**Committee of Experts on the Transport of Dangerous Goods
and on the Globally Harmonized System of Classification
and Labelling of Chemicals****Sub-Committee of Experts on the Transport
of Dangerous Goods****Forty-first session**

**Updating the Globally Harmonized System of
Classification and Labelling of Chemicals:
physical hazards****Amendments to the classification flow chart/decision logic for
self-reactive substances and organic peroxides****Transmitted by the International Council of Chemical Associations
(ICCA)¹****Introduction**

Figure 2.4.1: FLOW CHART SCHEME FOR SELF-REACTIVE SUBSTANCES
Figure 2.5.1: FLOW CHART SCHEME FOR ORGANIC PEROXIDES

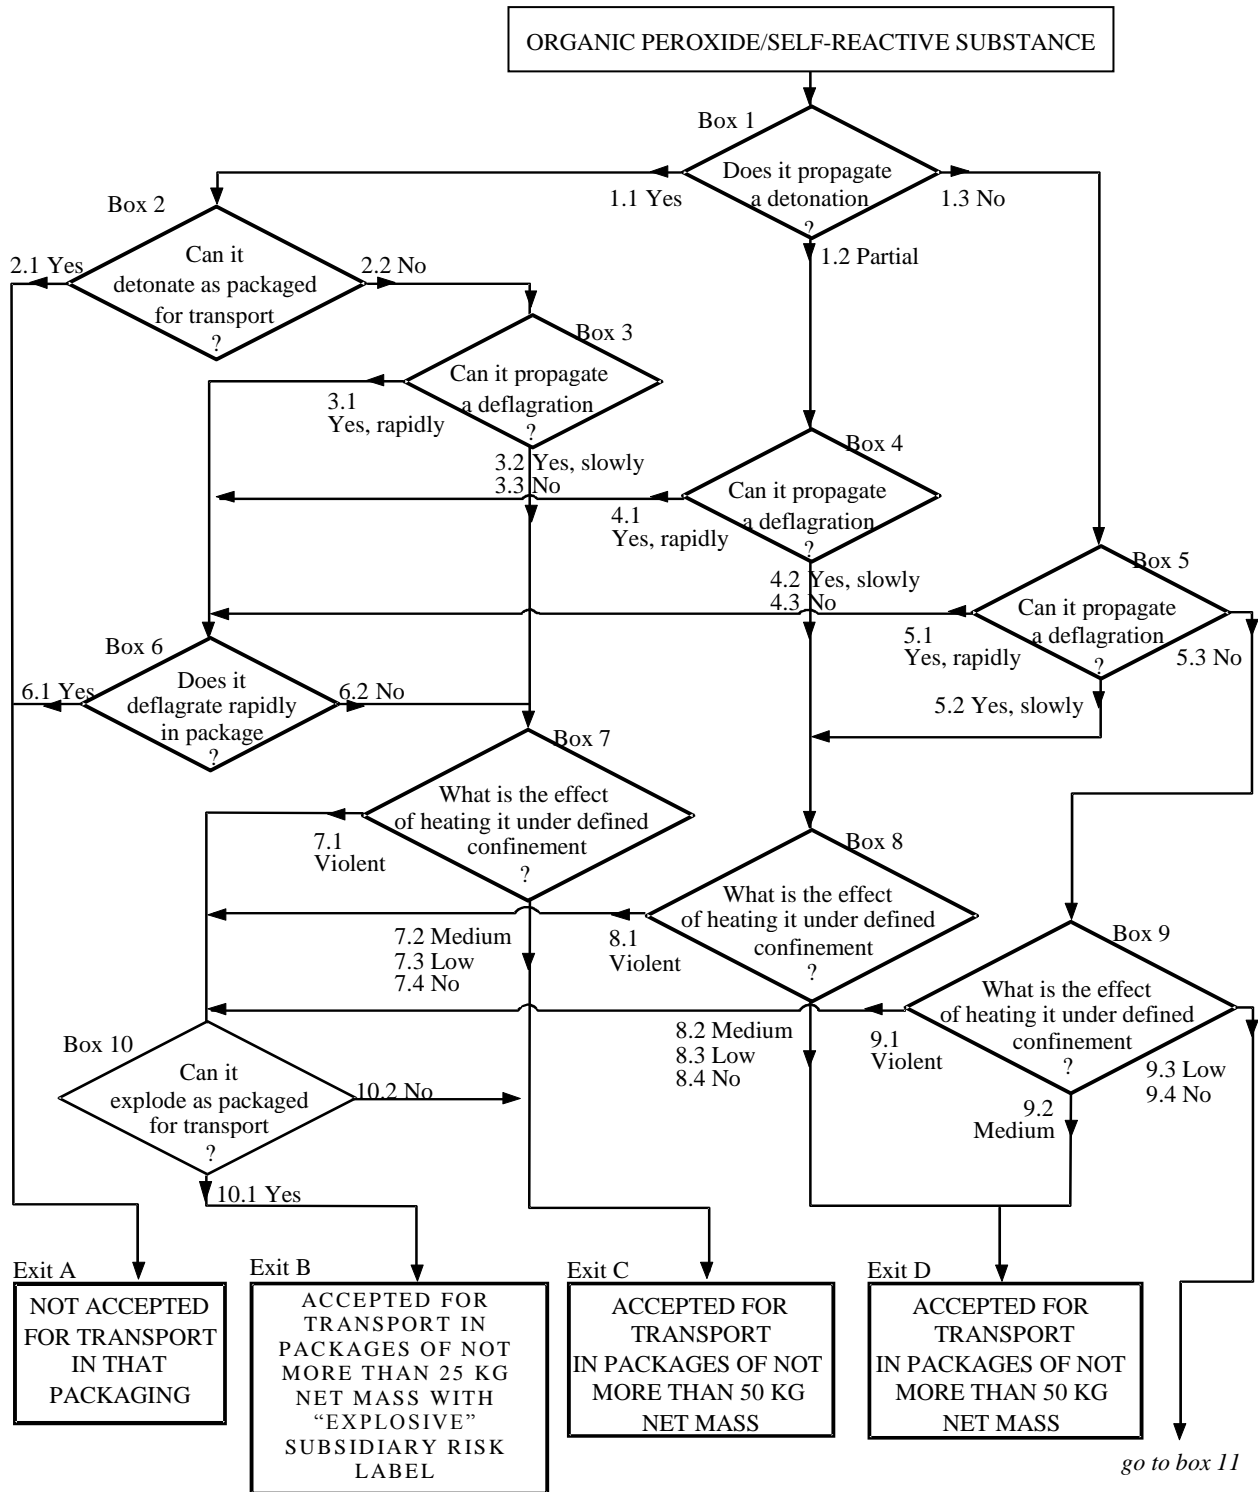
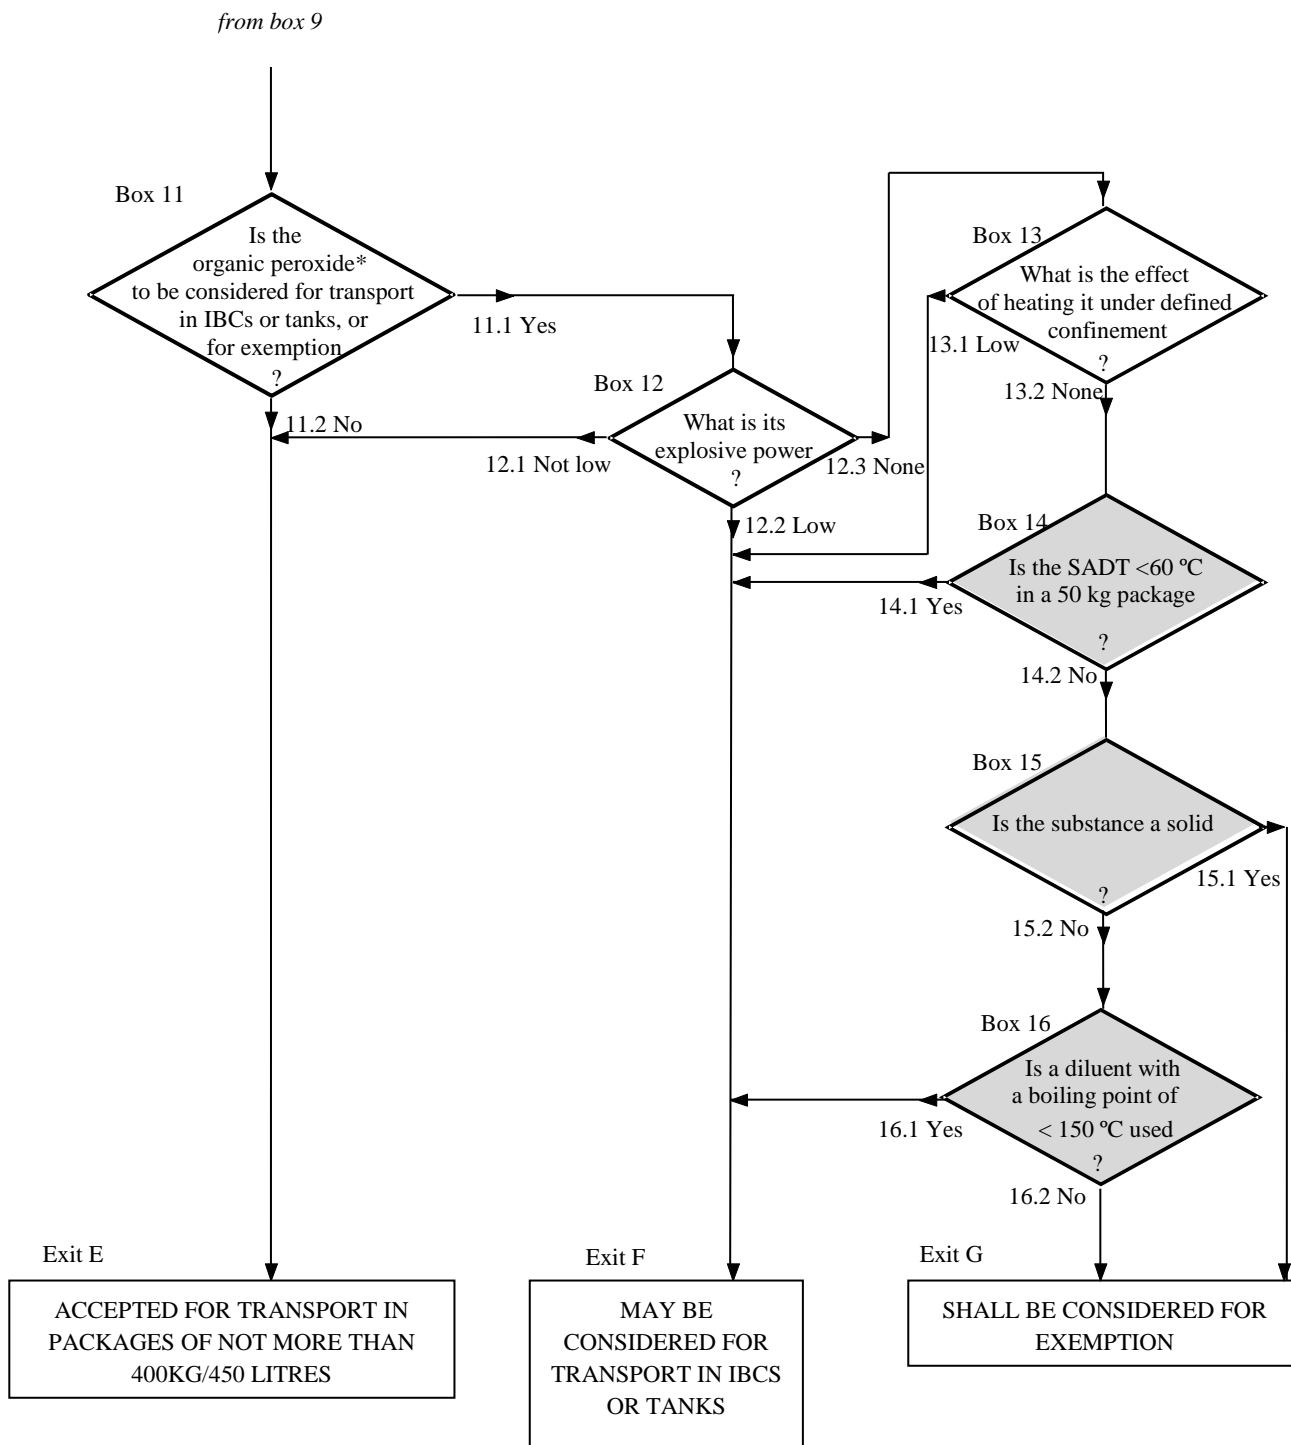
(a) no type G classification possible if the Self-accelerating decomposition temperature (SADT) of the substance is $< 60\text{ }^{\circ}\text{C}$ in a 50 kg packaging (see Model regulations paragraphs 2.4.2.3.3.2 (g) and 2.5.3.3.2 (g) and GHS paragraphs 2.8.2.2 (g) and 2.15.2.2 (g))

(b) no type G classification possible when a diluent is used with a boiling point $< 150\text{ }^{\circ}\text{C}$ (see Model regulations paragraphs 2.4.2.3.3.2 (g) and 2.5.3.3.2 (g) and GHS paragraphs 2.8.2.2 (g) and 2.15.2.2 (g))

8. In the proposed amended flow chart these two aspects are addressed in the new boxes 14 and 15 respectively. The introduction of these boxes will not lead to a change in the existing classification principles.

(a) In the Chapters 2.4 and 2.5 of the Model Regulations replace Figures 2.4.1 and 2.5.1 by the following:

Decision logic 2.8 for self-reactive substances and mixtures
Decision logic 2.15 for organic peroxides

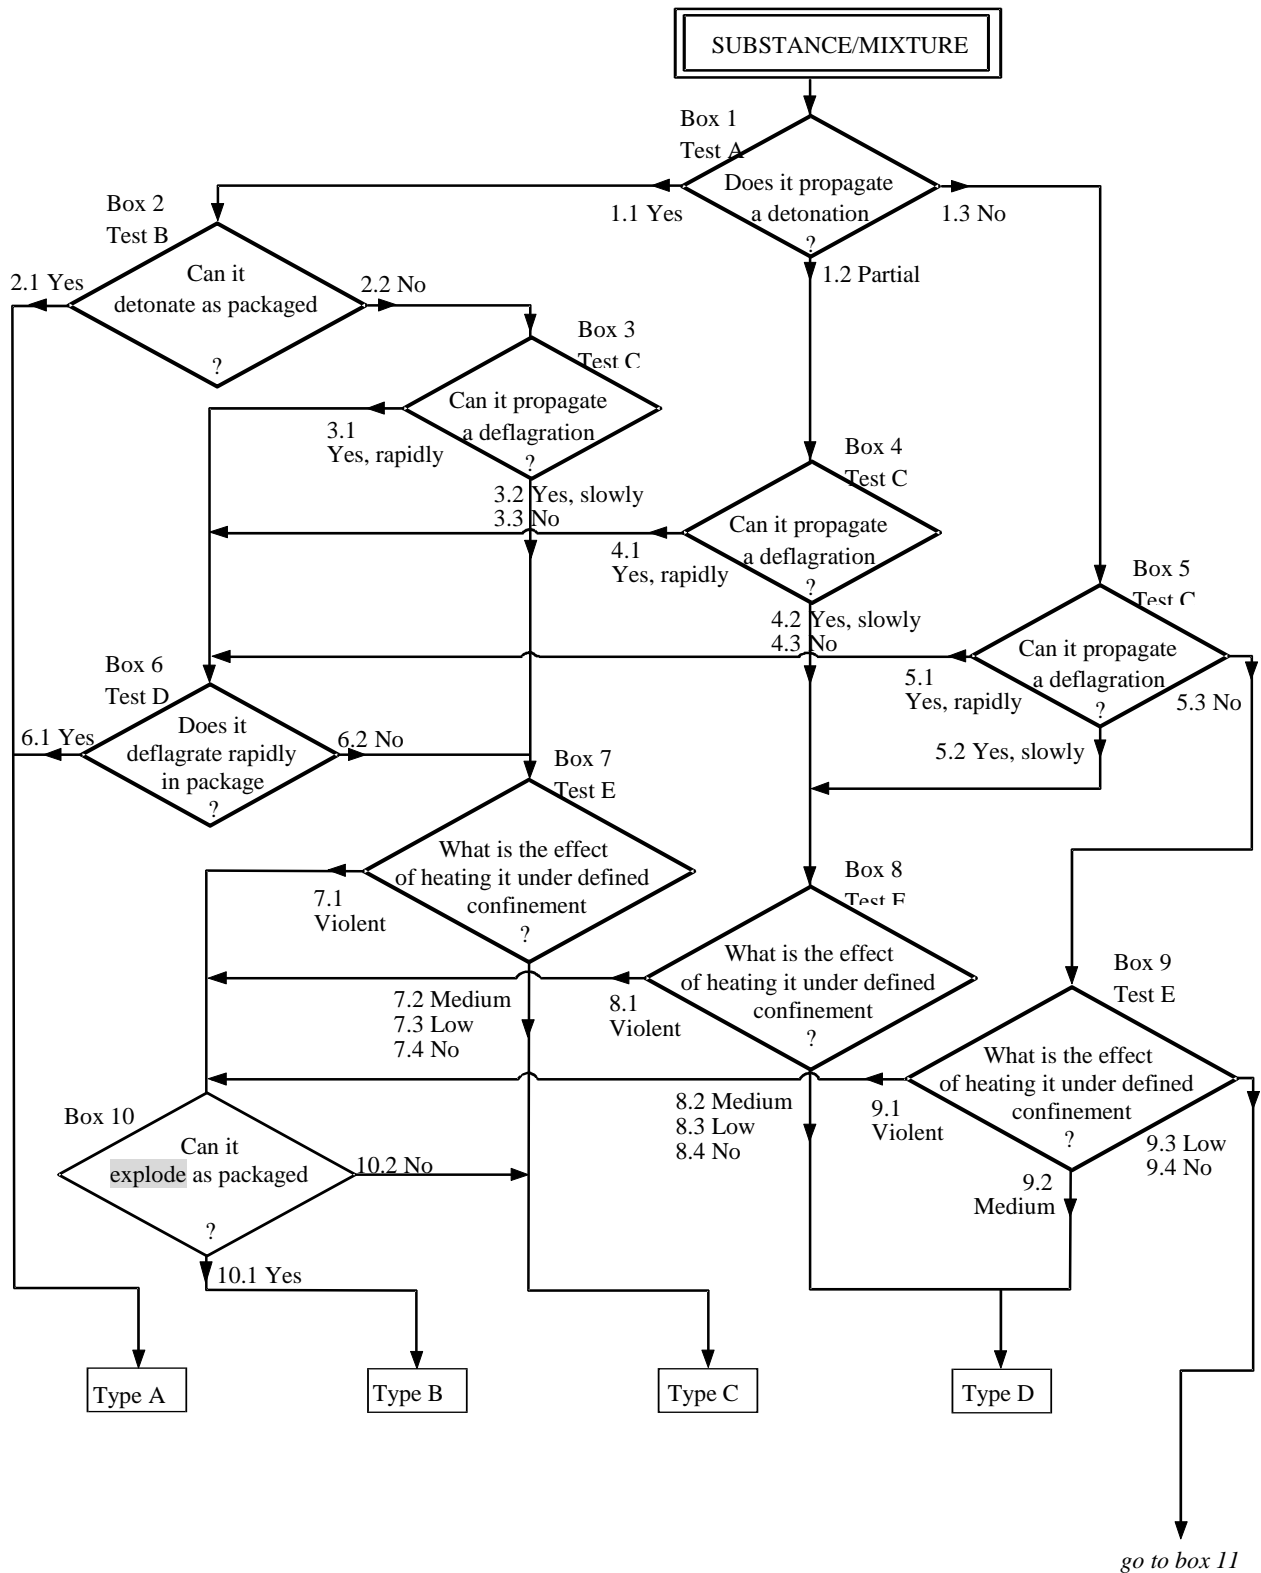
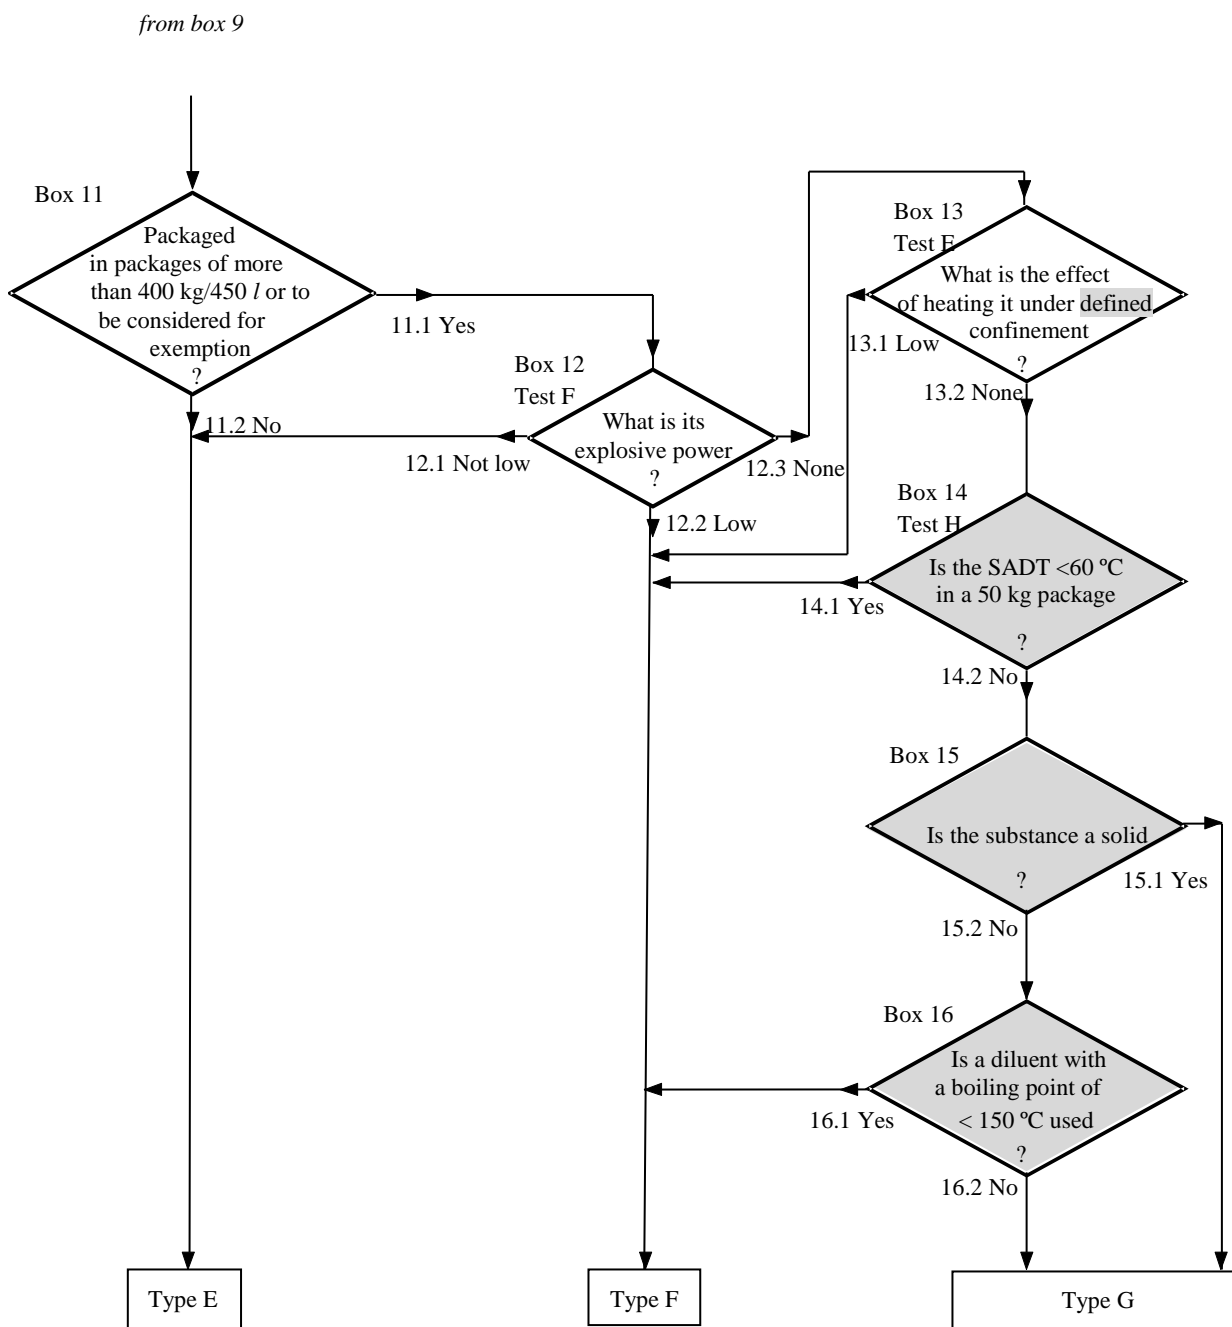
(b) In Chapters 2.8 and 2.15 of the GHS replace decision logics 2.8 and 2.15 by the following:

(Note: the grey shaded wording in boxes 10 and 13 are just corrections.)
